MUFFLER GUARD HEAT SHIELD

MQ Part # 802755

Production change **Serial Number - 130201** Production change **Date - 2/2013**

Image: Muffler shield mounted

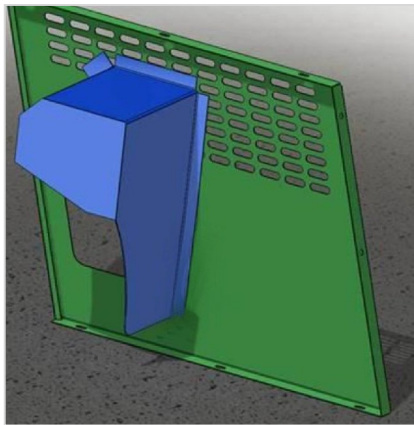
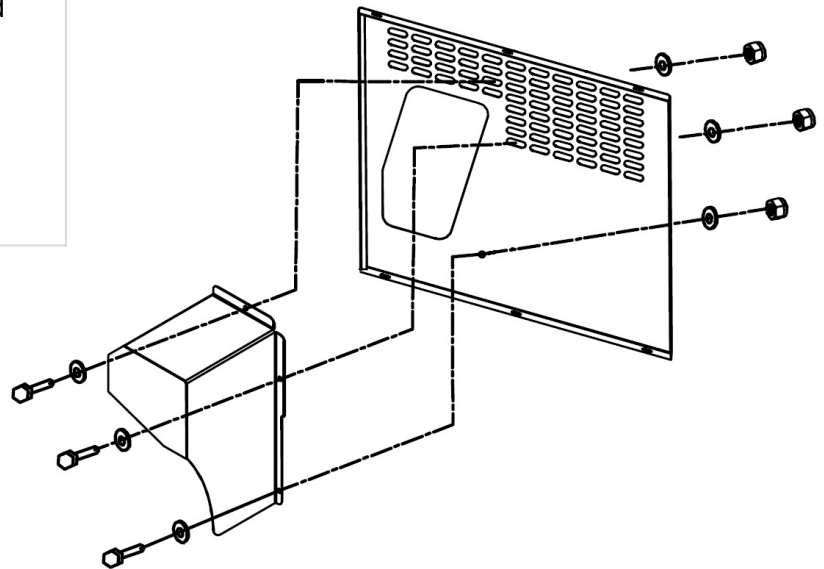
A new engine muffler shield has been developed to replace the existing Honda muffler shield. The new shield is better secured reducing the possibility of loose hardware.

Installing requires drilling (1) new hole for mounting and bolting up to existing holes on the side panel.

Location of new bolts to secure muffler heat shield to side panel
